**RE: LOT 137 TELLURIDE MOUNTAIN VILLAGE – VESTED PROPERTY RIGHTS MEMO**

**137 GR**  
DRB - FINAL

137  
GRANITE  
RIDGE

# DRB FINAL RESPOSE JUNE 1, 2023 DRB CONDITIONS

# CM1.1

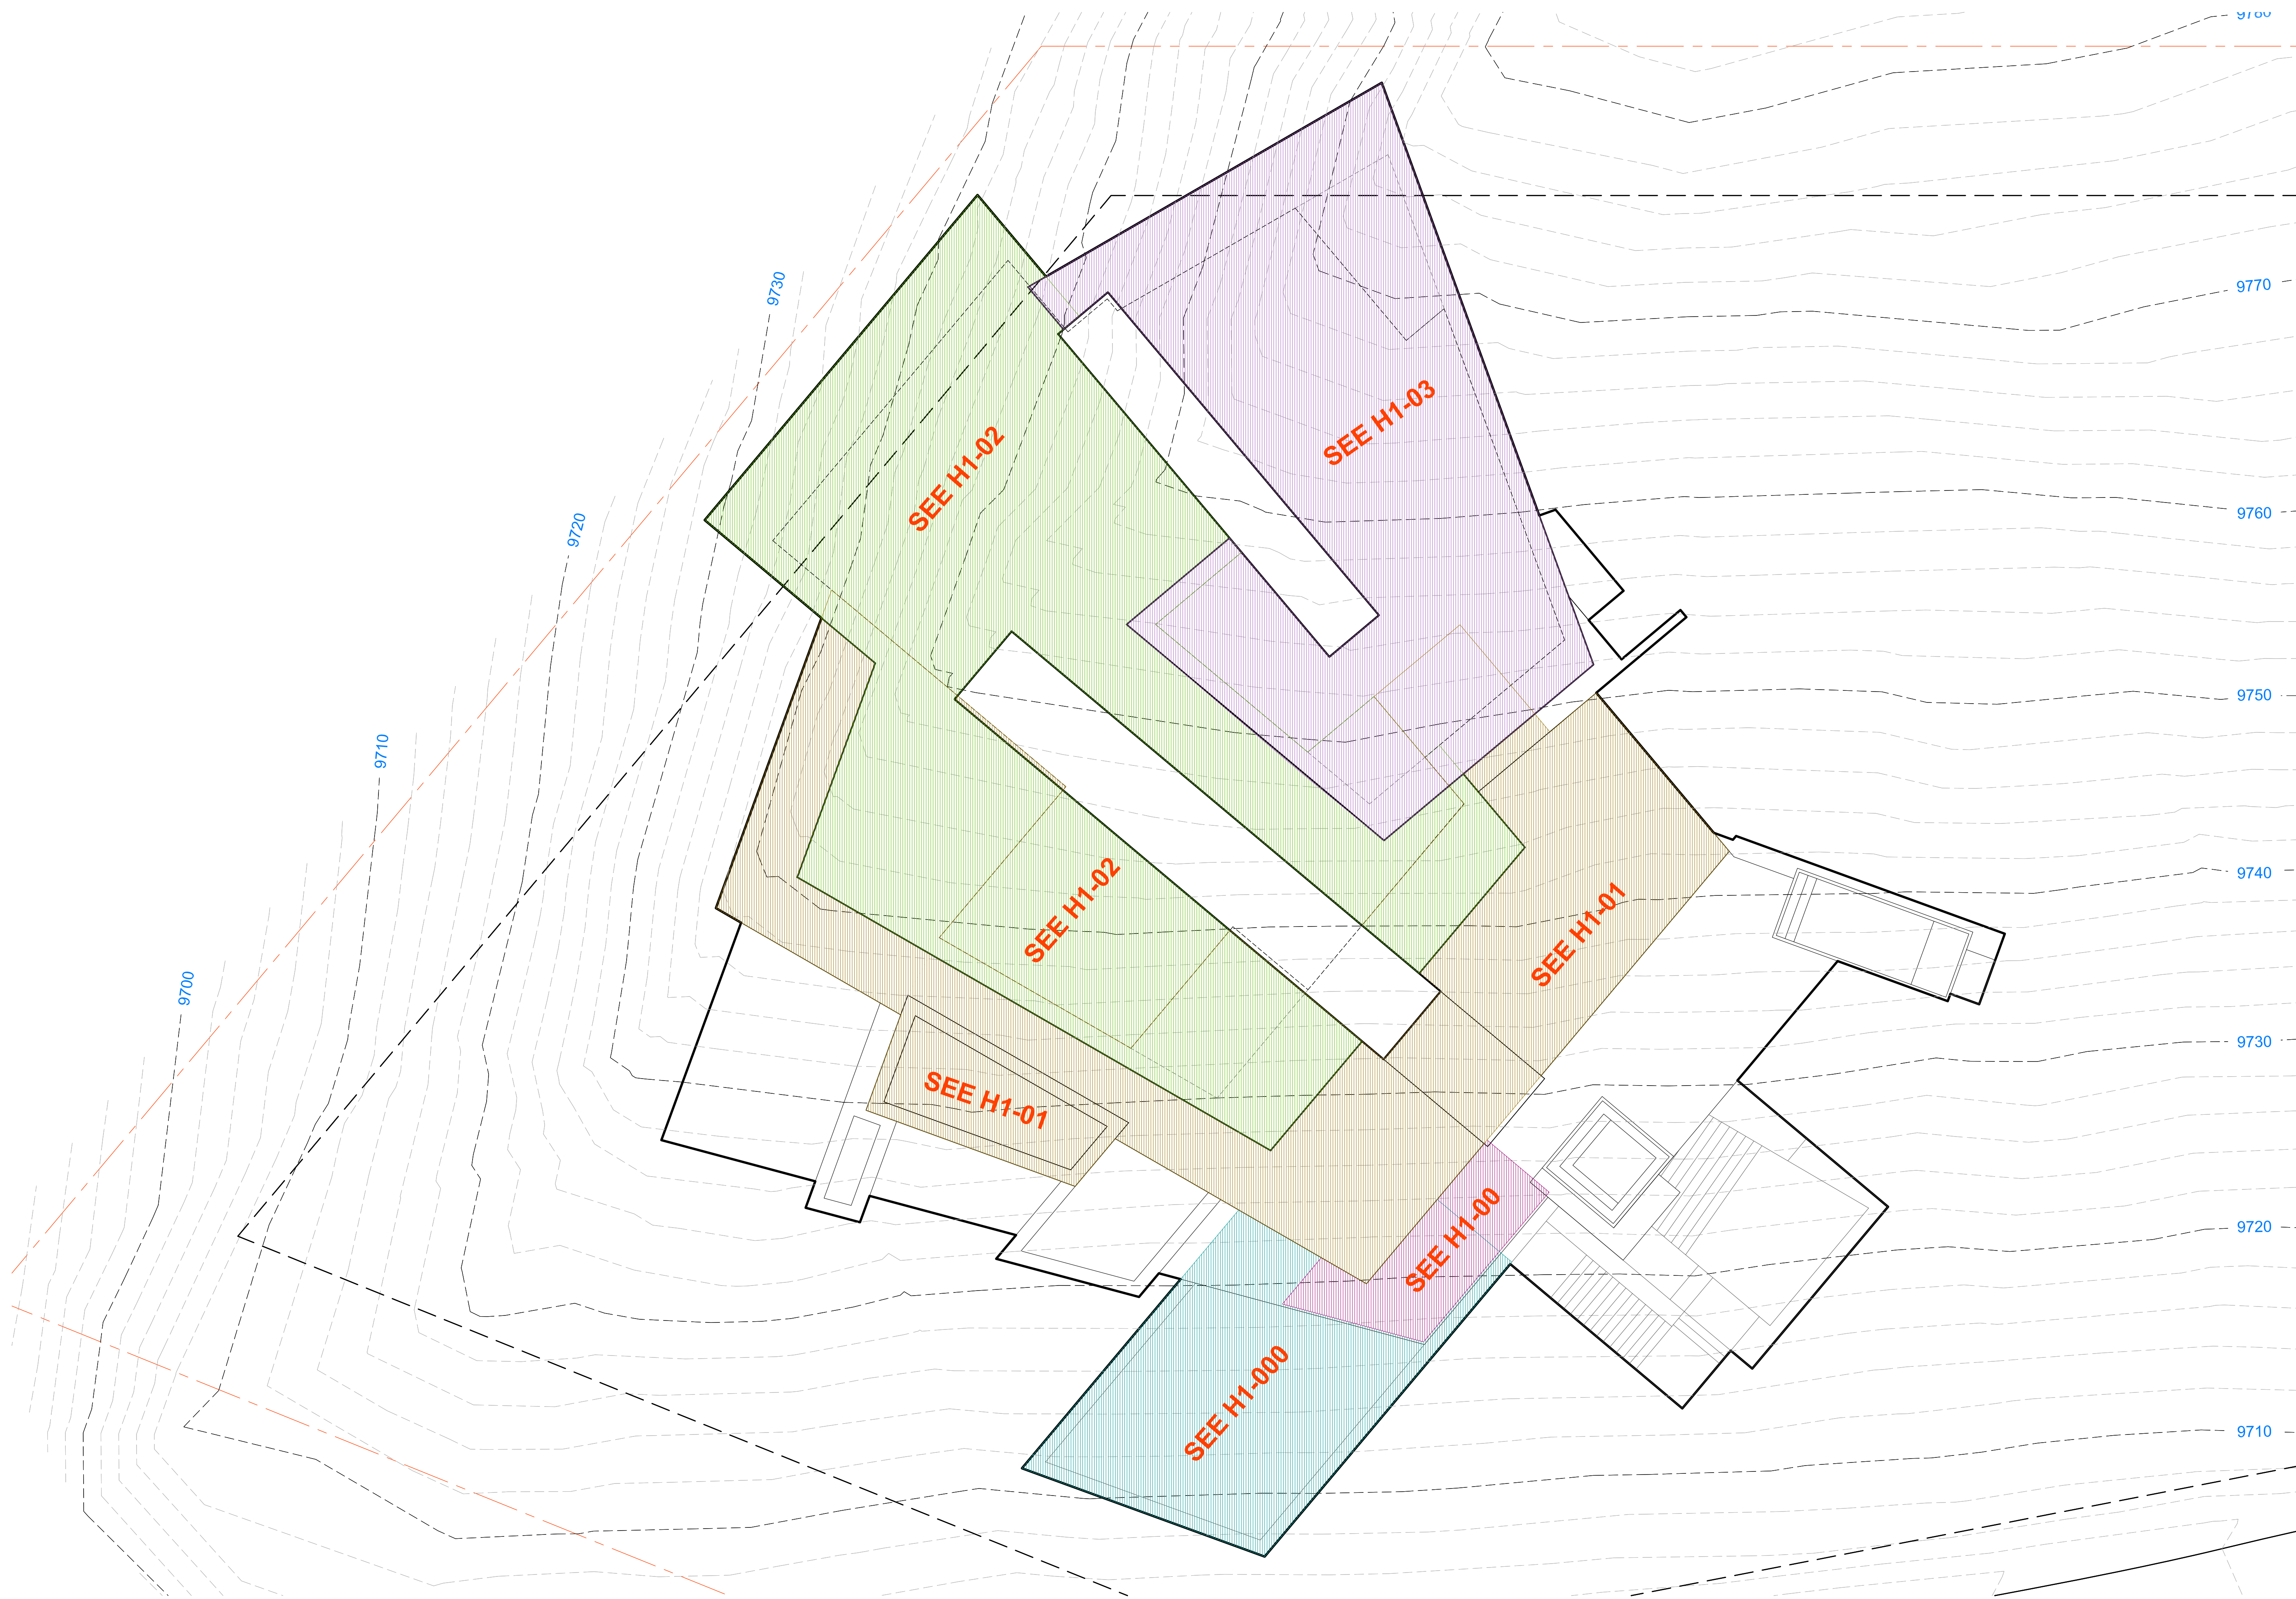
- 11) PRIOR TO FINAL REVIEW, THE APPLICANT SHALL ADDRESS CONCERNS LISTED IN THE CONSTRUCTION MITIGATION PLAN.
- 12) THE "PREP KITCHEN" ON THE UPPER LEVEL SHALL MEET THE DEFINITION OF A WET BAR.

SEE SHEET CM1.1

**A2.04R**

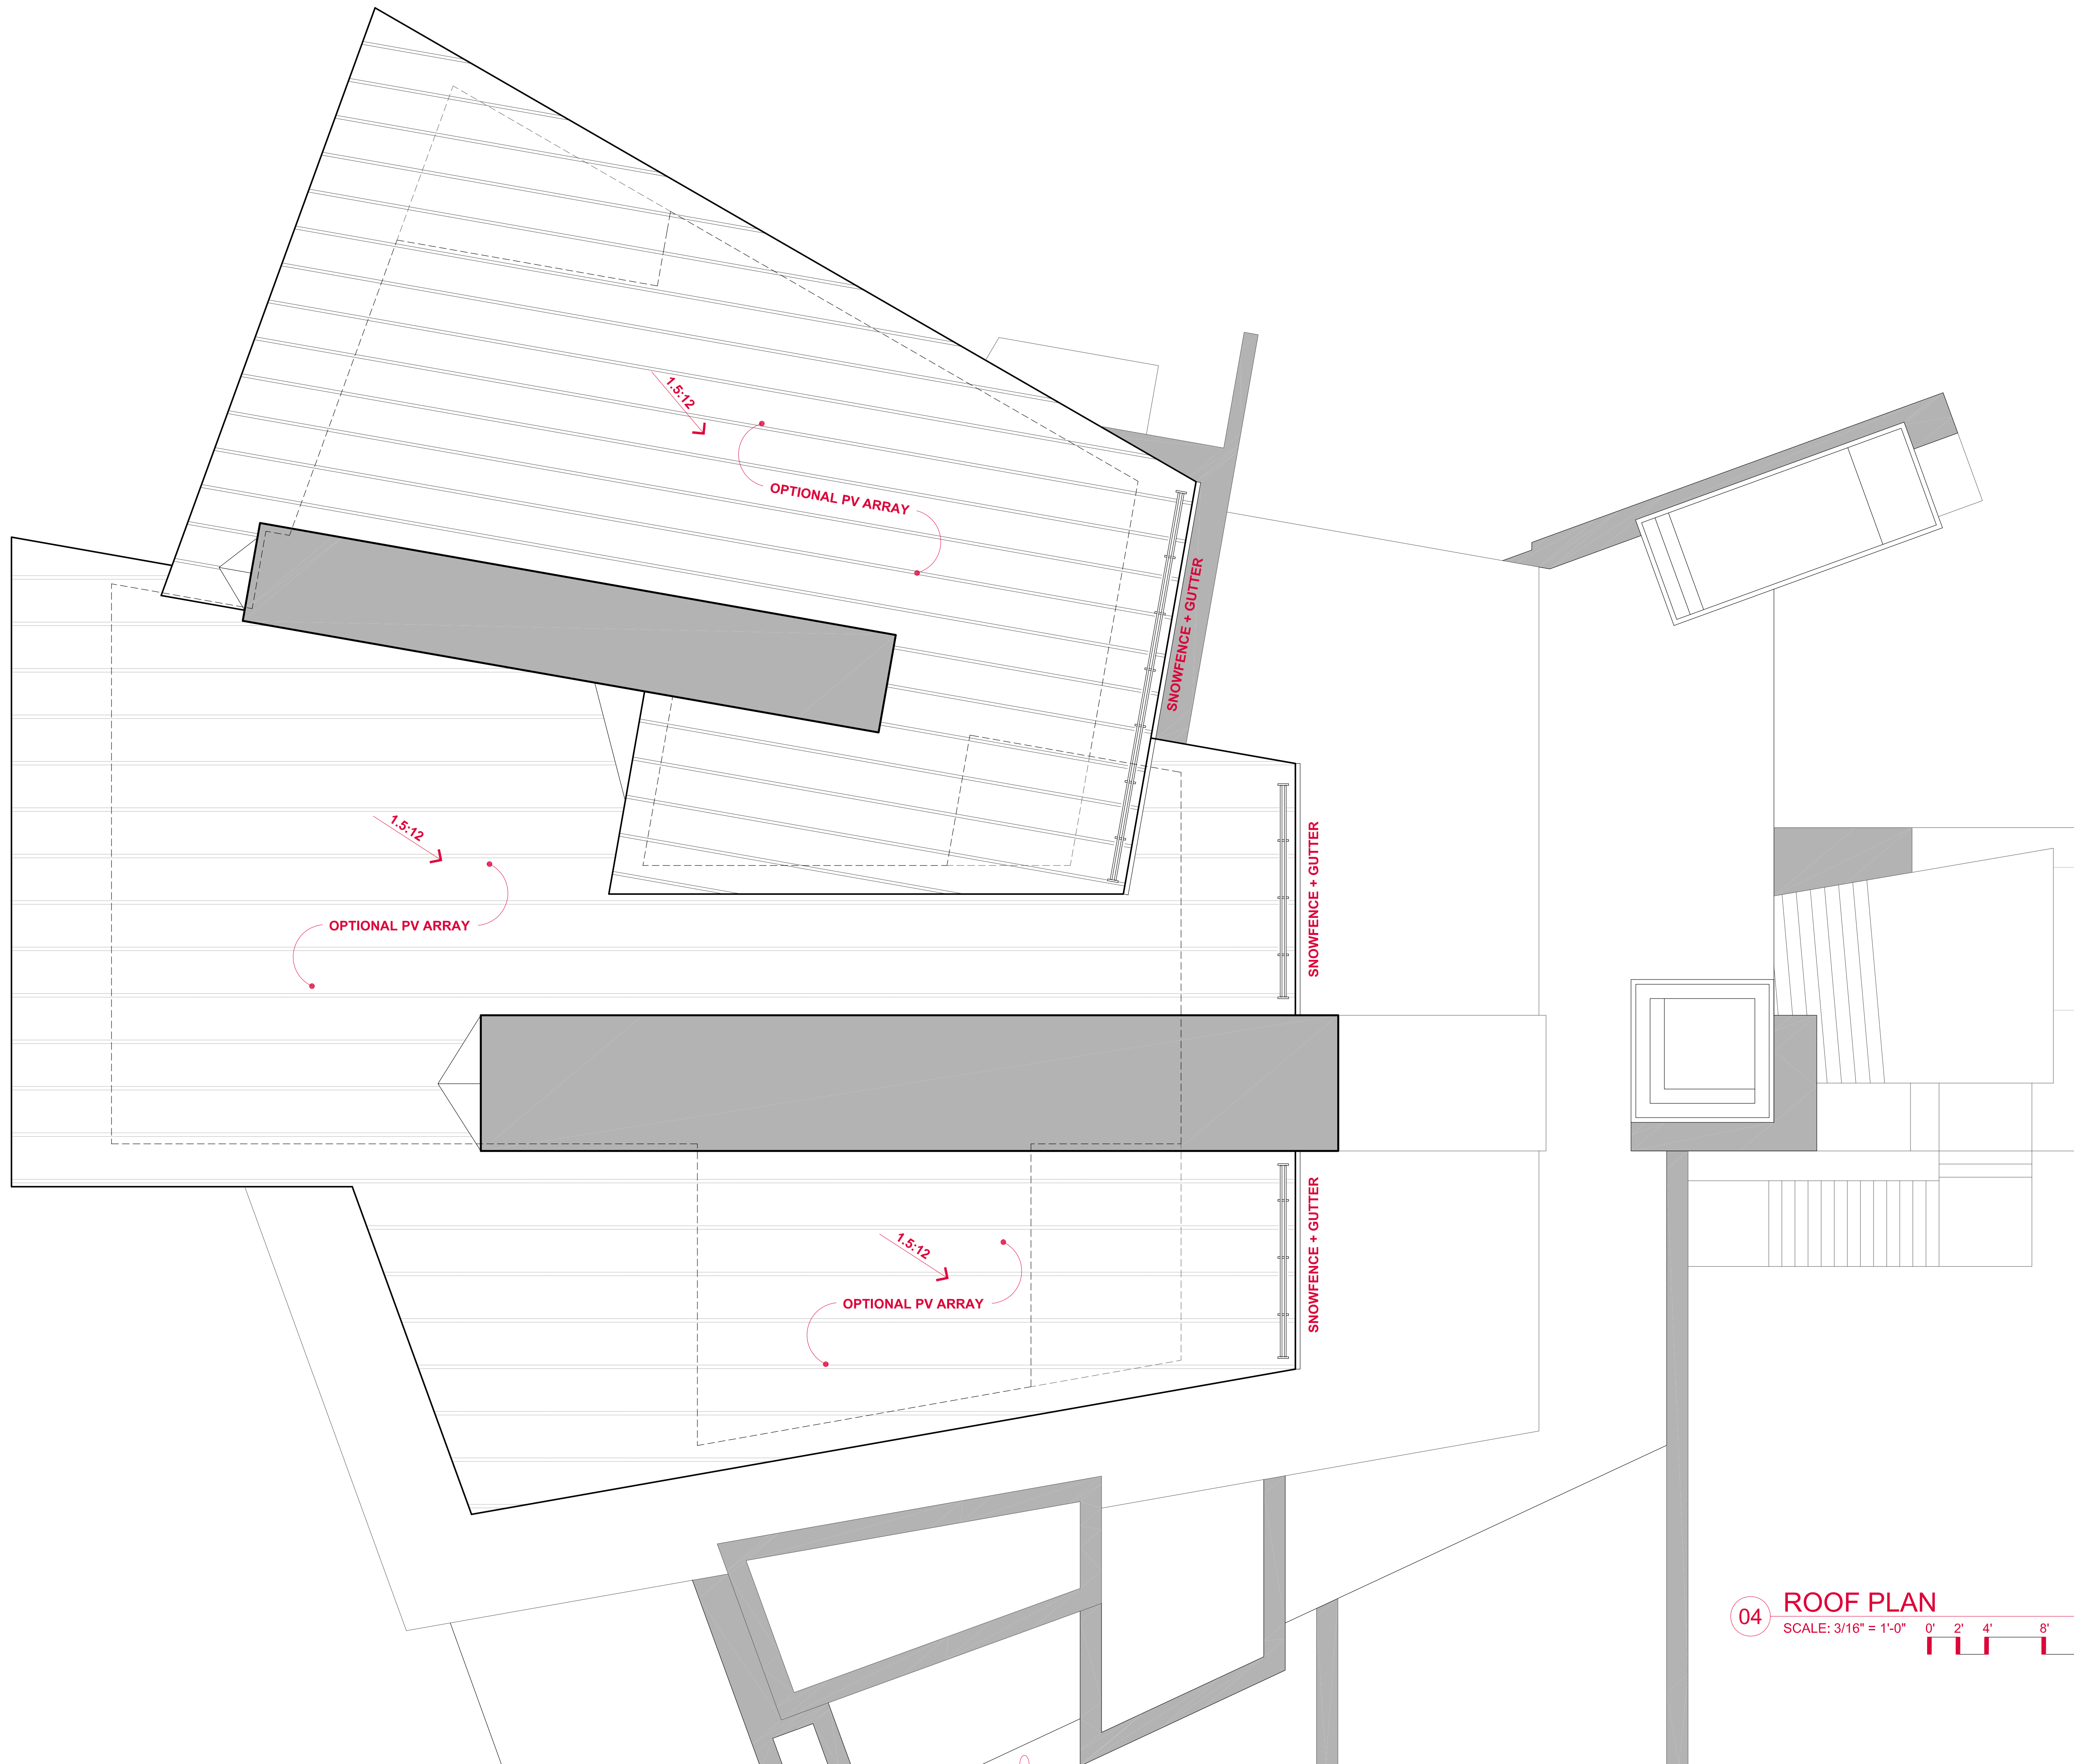
- 22) AT FINAL REVIEW THE DRB RECOMMENDATIONS WILL BE CONSIDERED. PRIOR TO FINAL REVIEW THE UPPERMOST STONE BAR WILL BE PULLED BACK AND THE HEIGHT WILL BE REDUCED.

SEE SHEET A2.04R, H-V & A3.1
